VIOLATIONS TO BE FIXED

220 31 STREET

NOTICE OF VIOLATION. BVC19000436220 31 STREET.

NOTICE OF VIOLATION BVC19000449. 220-224 31st St.

GUARD RAIL TYP ELEVATION
N.T.S.

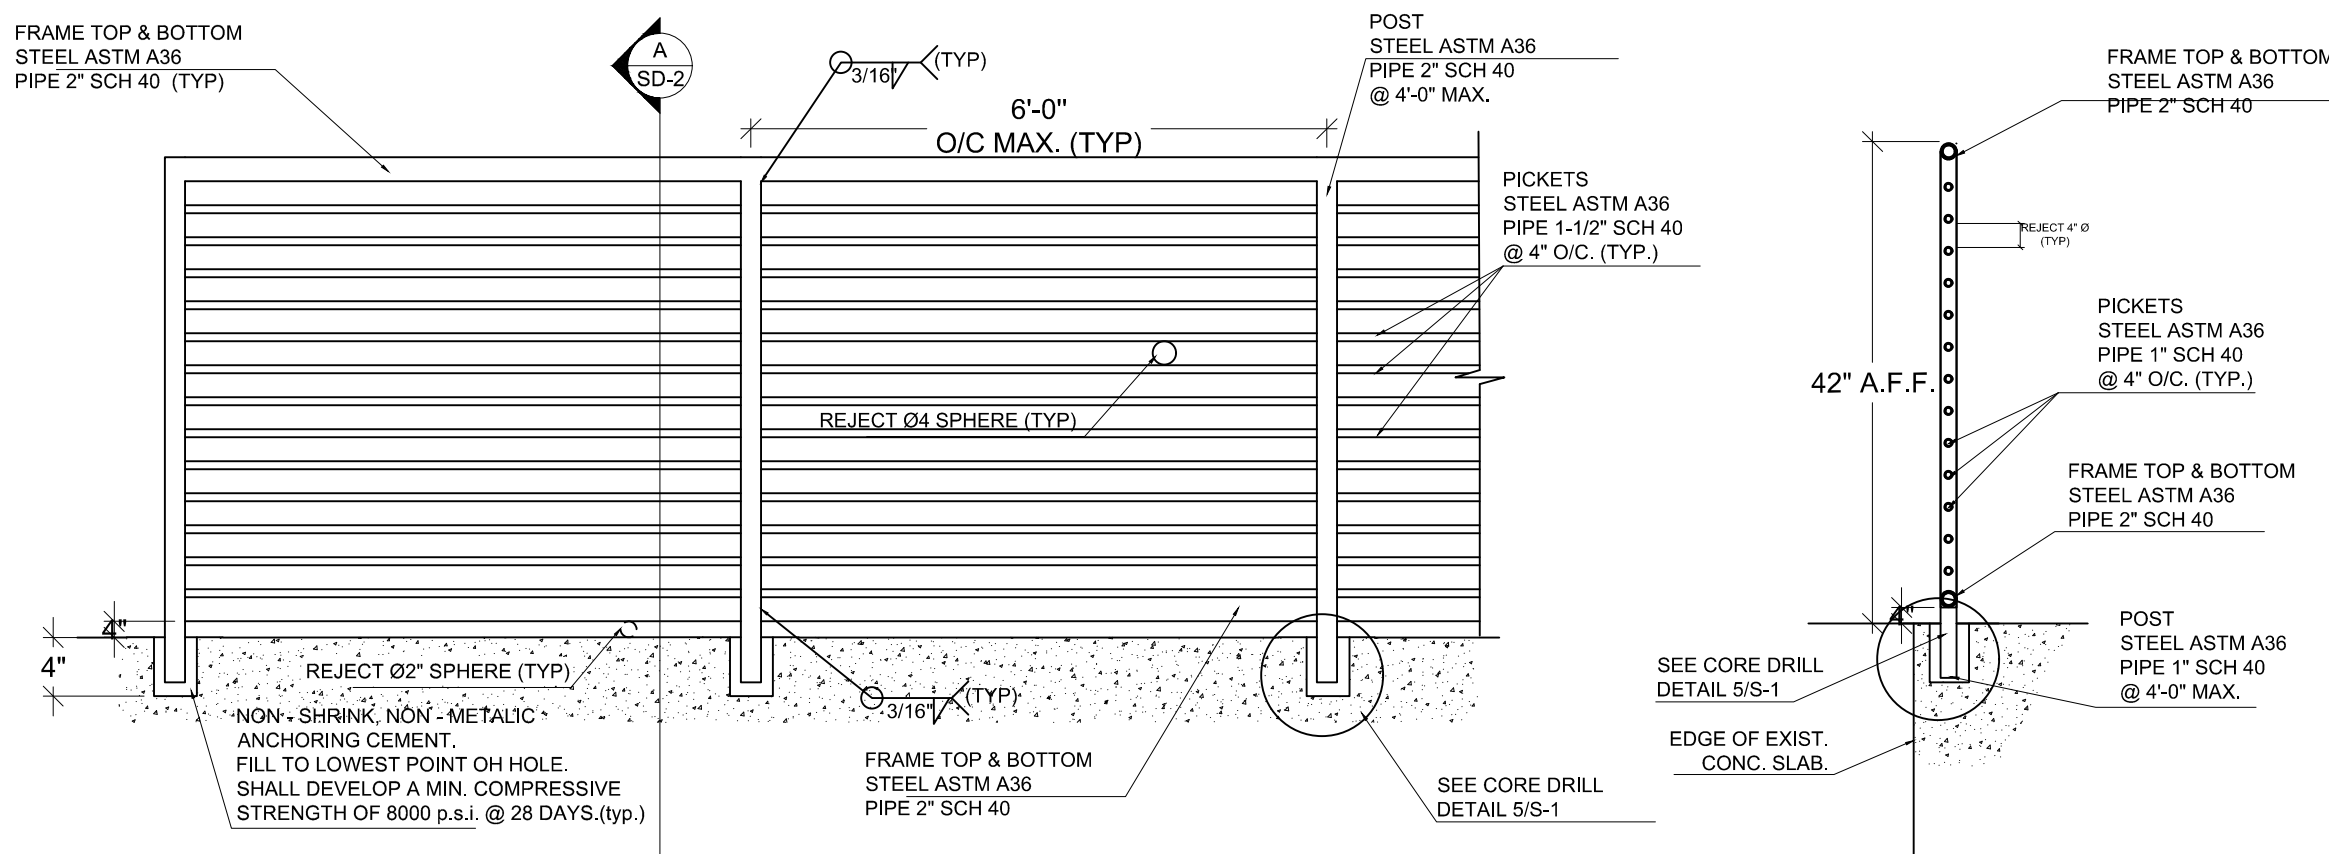
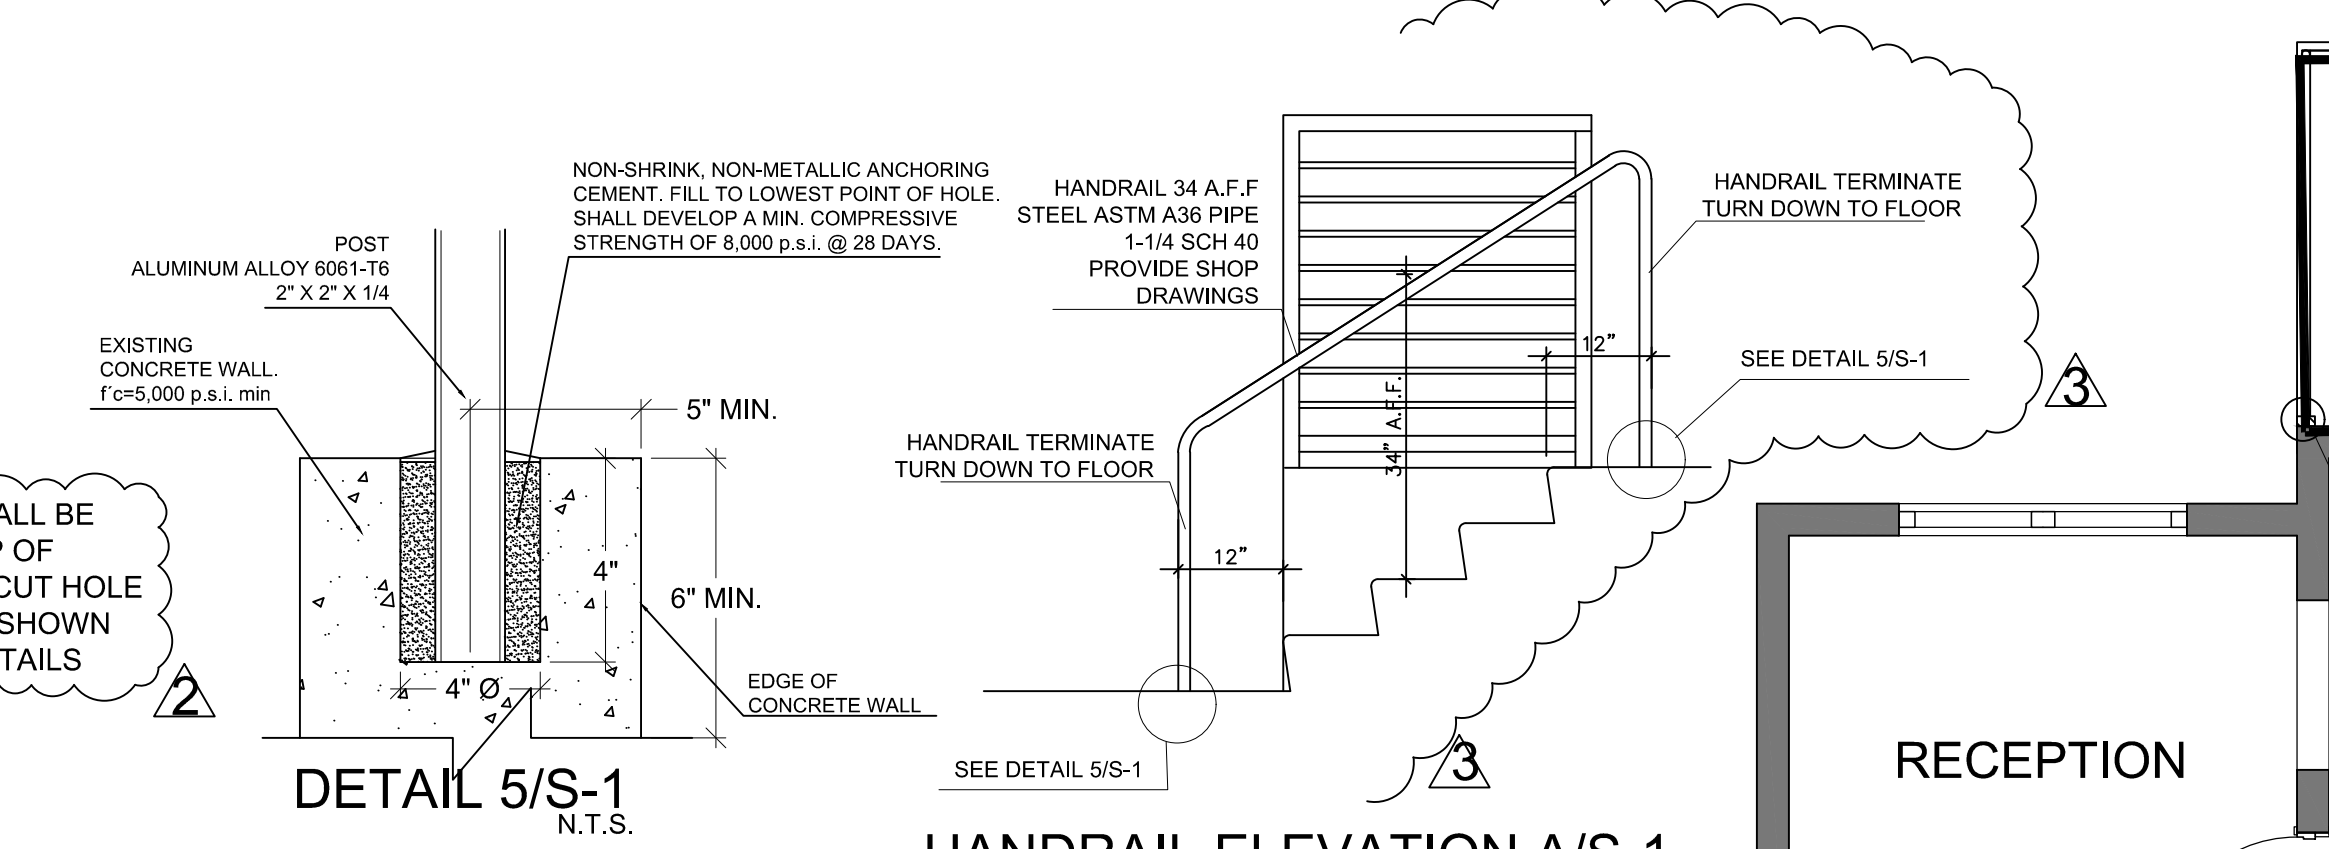
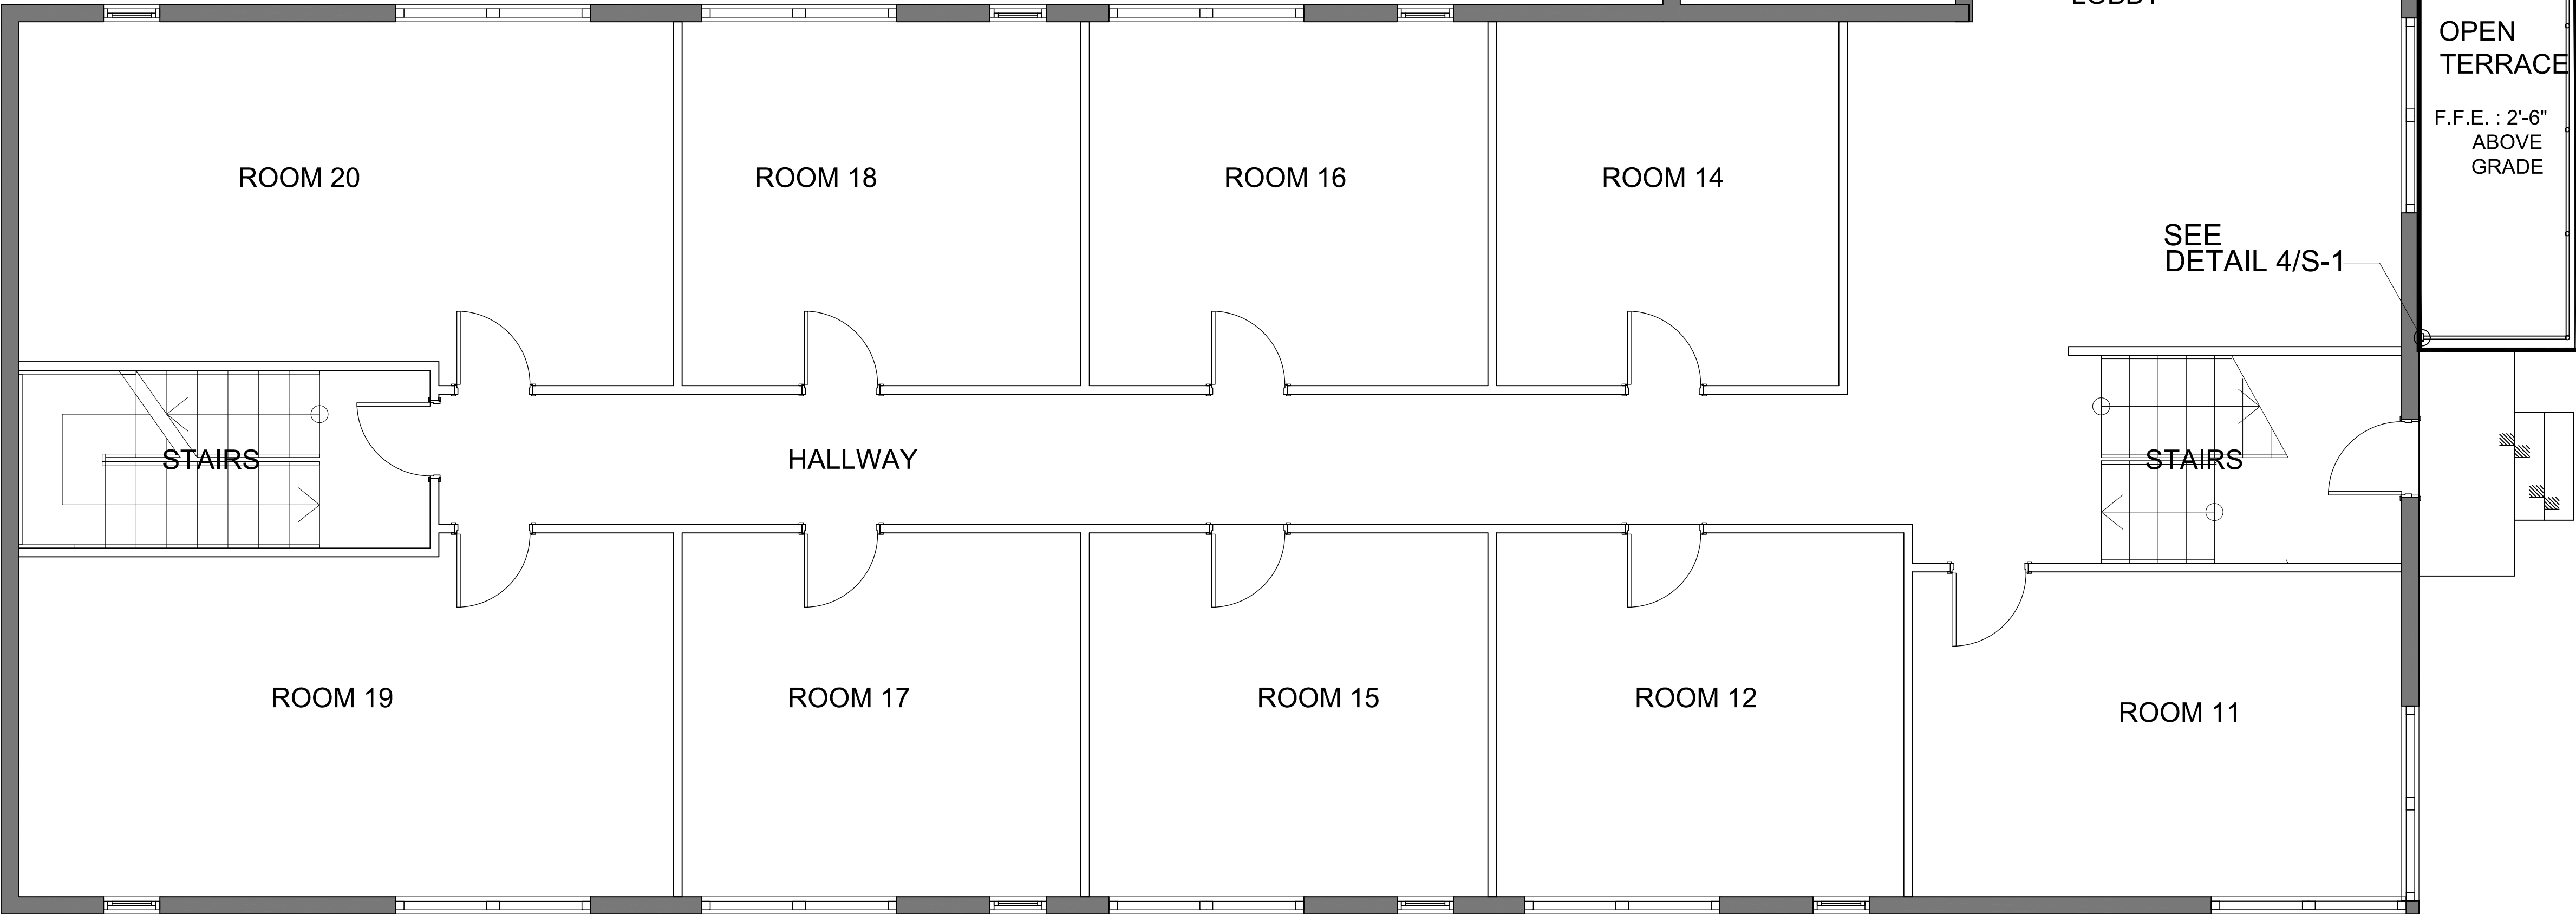
PLANNING REVIEW
Revision horizontal railing to incorporate 6
inch opening above 36' A.F.F.
R/. RAILING TO BE UP-DATED AS SHOWN
ON SHEET S-1 RAILING 42" A.F.F WITH
MAX 4" REJECT.
